(Shearon Harris Nuclear Power Plant,
Units 1 and 2)

AFFIDAVIT OF JAI RAJ N. RAJAN, HERBERT F. CONRAD
AND PAUL C.S. WU, IN SUPPORT OF NRC STAFF'S RESPONSE TO APPLICANTS'
MOTION FOR PARTIAL SUMMARY DISPOSITION OF JOINT CONTENTION VII

SAFETY EVALUATION REPORT RELATED TO THE
D4/D5/E STEAM GENERATOR DESIGN MODIFICATION

Fig. 5.4-1. Radial profiles of various tube expansions

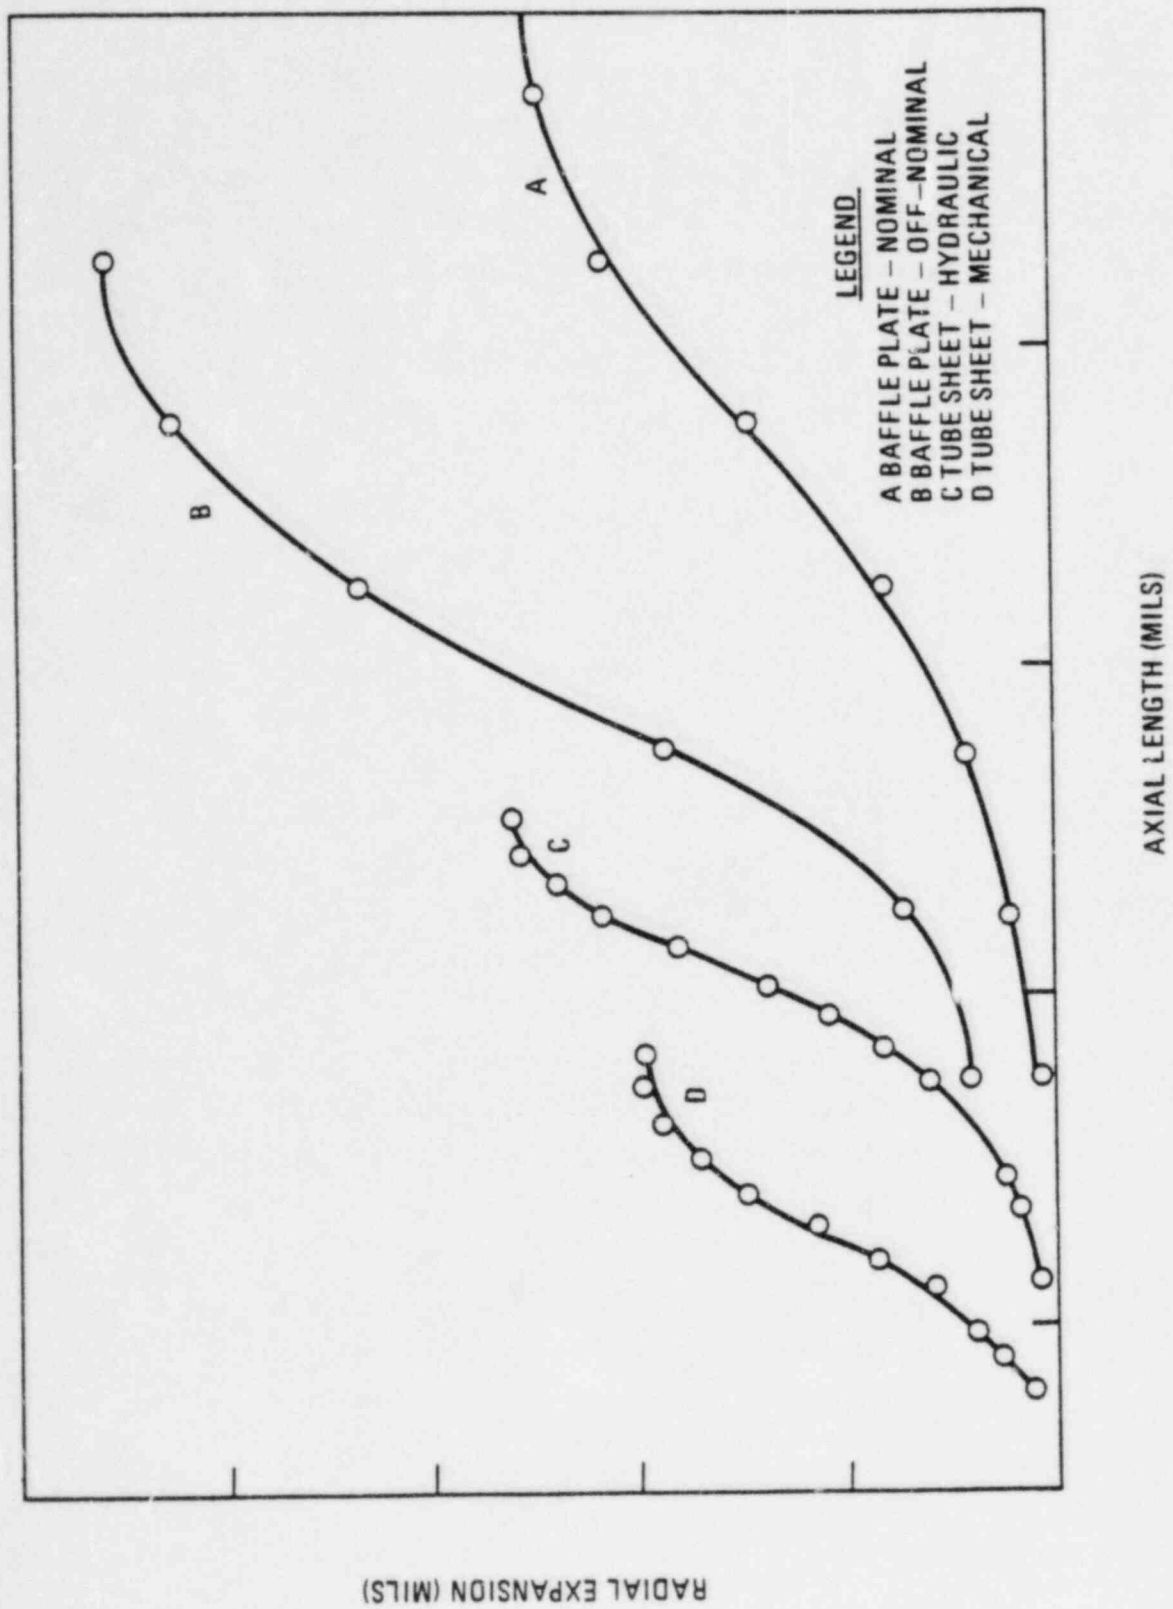
To further validate this conclusion, the TRC requested Westinghouse to provide plots of tube expansion profiles of tubes in tube sheets and those that result from baffle plate expansion. Figure 5.4-1 presents the radial expansion tube profiles as a function of axial distance along the transition for both tube sheet and baffle plate expansions.

Figure 5.4-1 shows that the nominal baffle plate expansion (Curve A) is more gradual than the hydraulic tube sheet expansion (Curve C). Therefore, it may be concluded that the residual stresses for the nominal baffle plate expansion are less than the residual stresses for the equivalent tube sheet plate expansion. The off-nominal baffle plate expansion (Curve B) is very similar to the hydraulic tube sheet expansion (Curve C) and is clearly better than the mechanically rolled tube sheet expansion (Curve D). In addition, the mechanical expansion inherently produces more residual stress than the equivalent hydraulic expansion.

Based on the above, the TRC believes that if this strain gradient relationship is maintained for the tube expansion process, the modification will not produce a stress condition on the tubes which is greater than what already exists for these tubes in the tube sheet region. Also, the existence of this condition lends considerable support to the conclusions on relative stress levels arrived at by the limited testing discussed previously. Therefore, having the strain gradient of the tube expansion equivalent to or less than that in the tube sheet provides, in conjunction with

Fig. 5.6-3. Relationship between normalized burst pressure and axial crack length of steam generator tubing

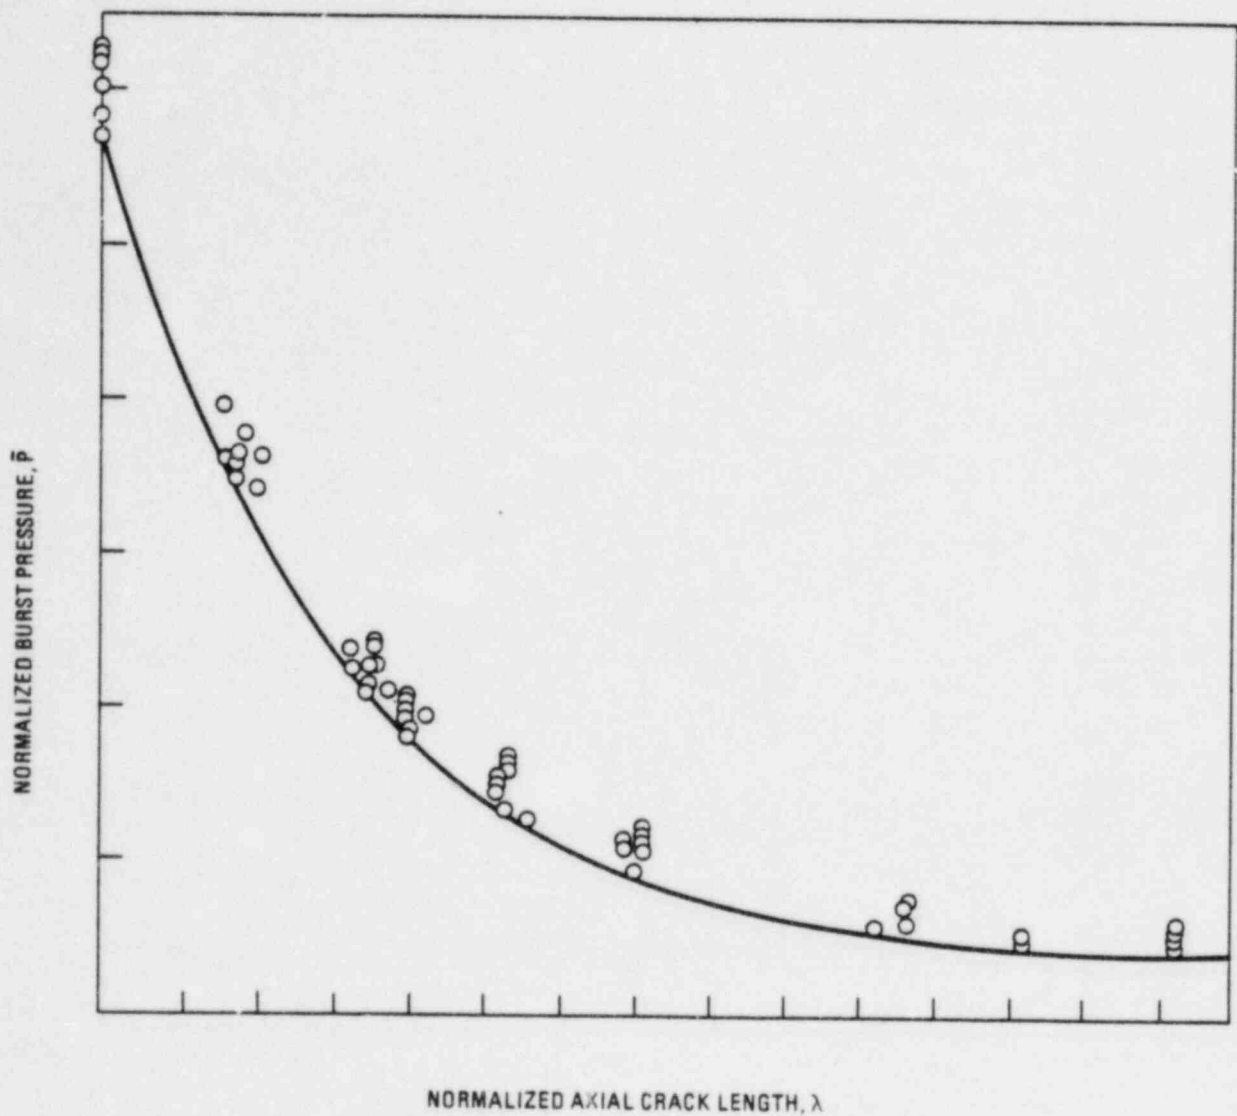
The second part of this evaluation involves determination of the critical crack length under an accident condition maximum ΔP_1 of 2650 psi. A data base was created by compiling the results of a large number of burst pressure tests performed on various Westinghouse steam generator tubing, within Westinghouse and elsewhere. Because of the variations in tube sizes and mechanical properties, the data were non-dimensionalized and are shown in Fig. 5.6-3. The figure shows excellent agreement between all the test results.

Fig. 5.6-4. Variation in margin to failure by burst as a function of R_m/t ratio

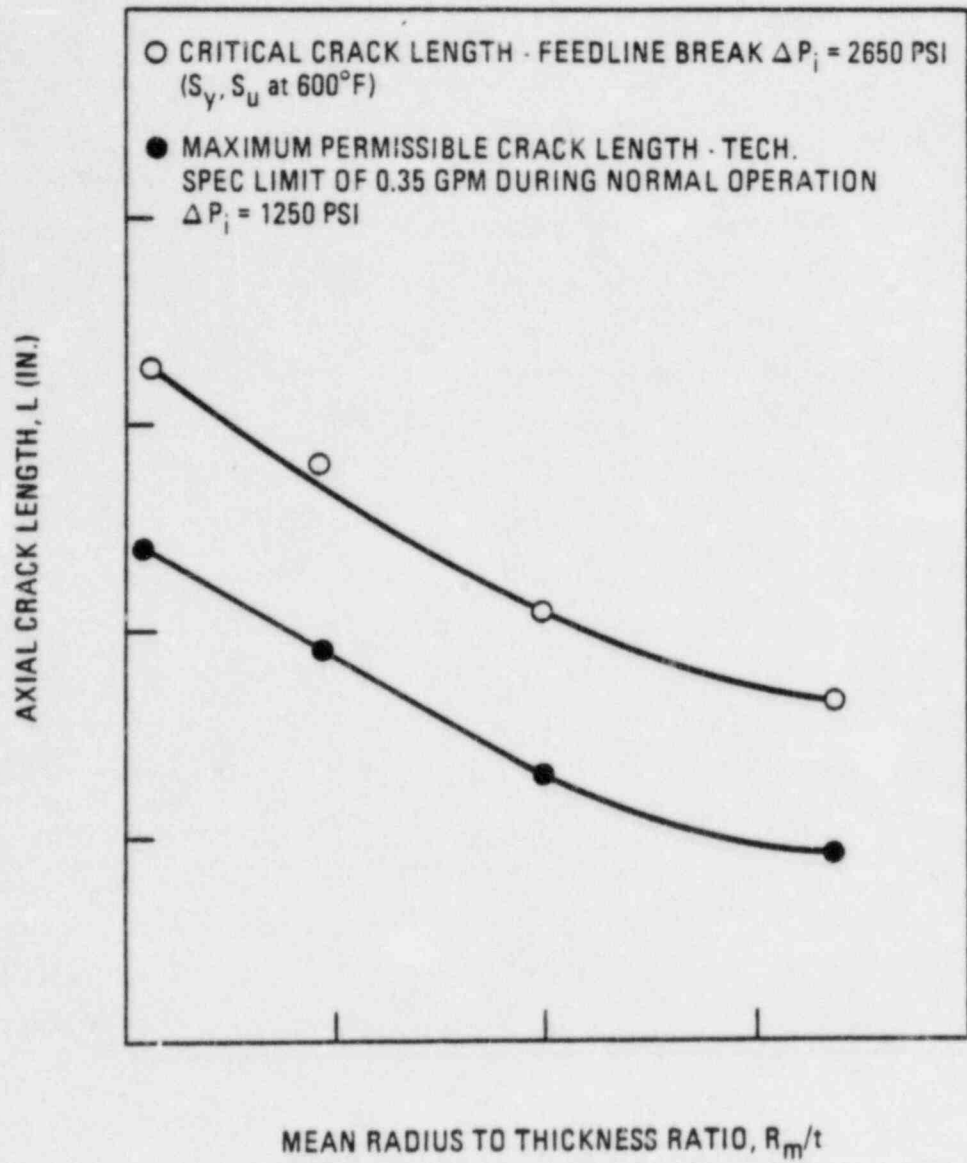
The effect of the expansion process will be to elevate the burst curve, as explained above, while no significant change would be expected in the leak curve. The mean radius to thickness ratio of the tubes increases slightly due to the expansion, from 8.8 to 9.9, but Fig. 5.6-4 shows there is no change in the leak-break margin as a result of this change.

Therefore, it is seen that the effect of the tube expansion process is to increase the margin between leak and break for the steam generator tubes.
